Subject: Block 57, Lot 9.01  
Americana Diner Parking, Hightstown, New Jersey 08520

Re: Planning Board Comments for October 11, 2022 Planning Board Meeting

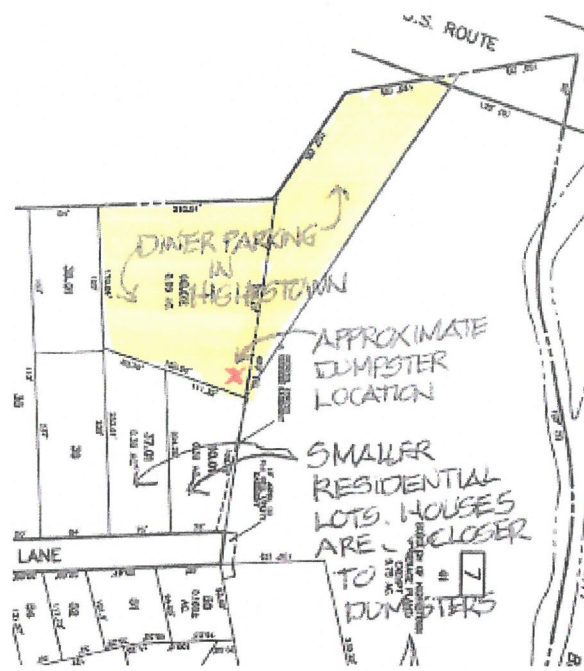
1. The dumpsters and compactors were moved out of the parking area in Hightstown, which is good. I like the 8' board on board fence as it will hide the dumpsters and compactors better. I would like to see the fence squared off to create more area to hide the garbage containers and junk currently behind the dumpsters.

The Board needs to decide if the compactors should be in the 25' Residential Buffer

The dumpster are close to the smaller residential lots.  
 They may affect the quality of life in the back yard of the houses on these lots.

Garbage containers and junk which should be behind the 8' board on board fence.

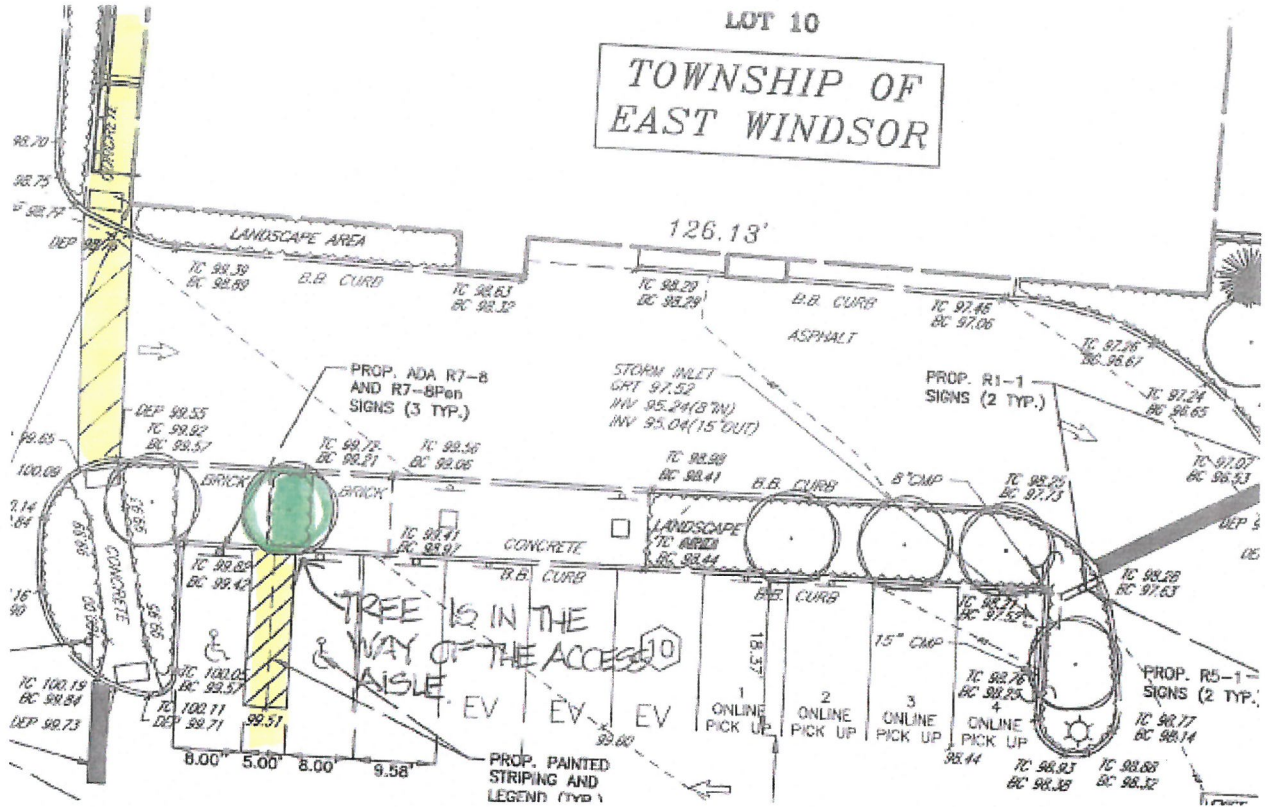
1. Two ADA spaces were added so that there are now six ADA parking spaces. This now meets New Jersey code, which is good.

The ADA access aisle terminates at a tree. The revised parking layout should go back to East Windsor for their review that the total ADA access path meets ADA requirements and for their approval of the changes.

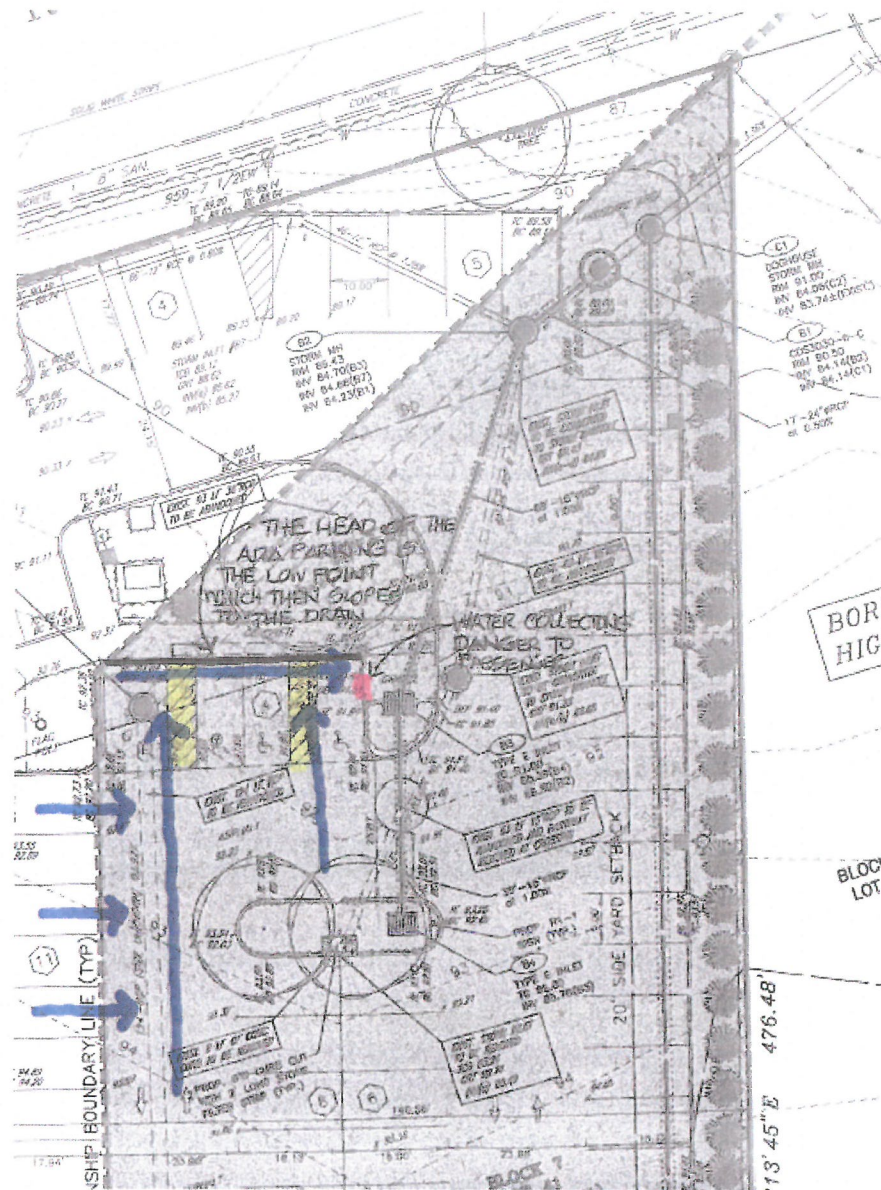
2. My main complaint has always been that the parking lot drains to the head of the ADA parking spaces. The water then flows to the drains to the right. Since it is a low point, all water will drain to the head of the ADA parking space before it flows to the drain. In a heavy rain, this may be a stream. The head of the parking space is where all the customers will have to walk to get to the sidewalk. This can be dangerous in the winter when the sun melts the snow and ice during the day and then the water freezes when the sun goes down. This is made worse because the ADA parking is white concrete while the parking lot is black asphalt. The black asphalt will absorb the sun's heat. The white concrete will reflect the heat. The water will remain wet on the dark asphalt and then freeze when it flows onto the cooler white concrete. It has eighteen feet of concrete to cool down on before it reaches the head of the parking space and then starts flowing to the drain. People using the ADA parking can have mobility and balance problems. They are more prone to slipping on the ice. Especially if using a cane. When they get out of the car, they all will have to transverse through the low area at the head of the parking space.

The head of the parking space is the low point which then slopes to the drain. The red area is where water collects and is a danger to customers getting out of the passenger side of the car.

The discoloration at the north end of the ADA parking space is a sign that water is collecting at that spot. This can freeze in the winter. This is dangerous for customers getting out of the passenger side of the car.

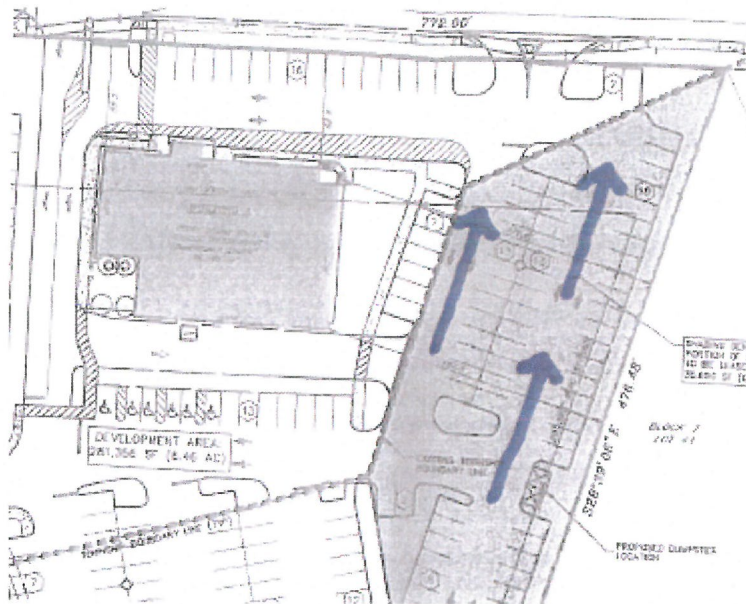
The ADA parking spaces should be sloping to the parking aisle so that the water does not collect and freeze in the ADA parking spaces. The parking lot should not drain to the ADA parking spaces. This is only giving the Borough increased liability of lawsuits resulting from customers slipping on the ice.

The original parking layout avoided draining to the head of the parking spaces.
